PUBLIC UTILITIES COMMISSION

Subject: Comments of the Public Advocates Office on the Draft GIS Data Reporting Standard version 2.2, Docket #2021-GIS-DRS

Figure 1:

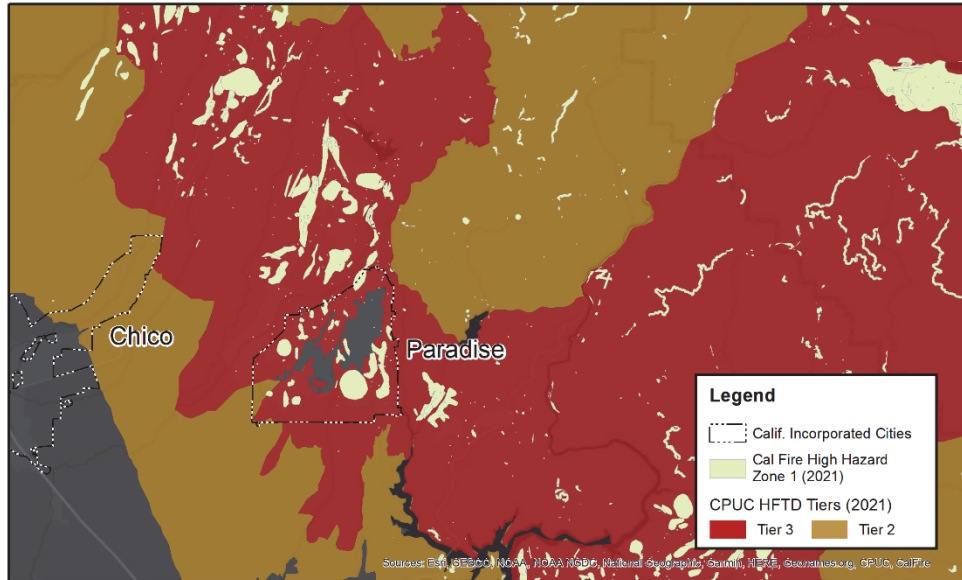
These categories are not in line with the categories that Energy Safety uses in its GIS Data Reporting Standard. Additionally, the term “Zone 1” is not mutually exclusive of HFTD Tiers 2 and 3. The California Public Utilities Commission's (CPUC’s) website on HFTD explicitly states that “Tier 3 and Tier 3 fire-threat areas on the CPUC Fire-Threat Map may overlap Tier 1 High Hazard Zones on the Tree Mortality HHZ Map.”¹⁶ Furthermore, the CPUC’s online HFTD Map shows that Zone 1 areas do overlap with Tier 2 and Tier 3.¹⁷

The above discrepancies lead to multiple points of possible ambiguity in written reports and in verbal discussions regarding HFTD. When utilities or Energy Safety discuss Zone 1, one must clarify if the term “Zone 1” refers only to those Zone 1 areas that are outside Tier 2 and 3, or if the term includes Zone 1 areas that overlap with Tiers 2 and 3. Additionally, when utilities or Energy Safety discuss Non-HFTD, one must clarify if the term “Non-HFTD” refers to all areas outside Tiers 2 and 3, or to all areas outside Tiers 2, 3 *and* Zone 1. Cal Advocates has no preference regarding which categorization is used. However, Energy Safety should choose one set of categorizations and definitions that is clearly defined and apply that standard to all data submissions from the utilities.
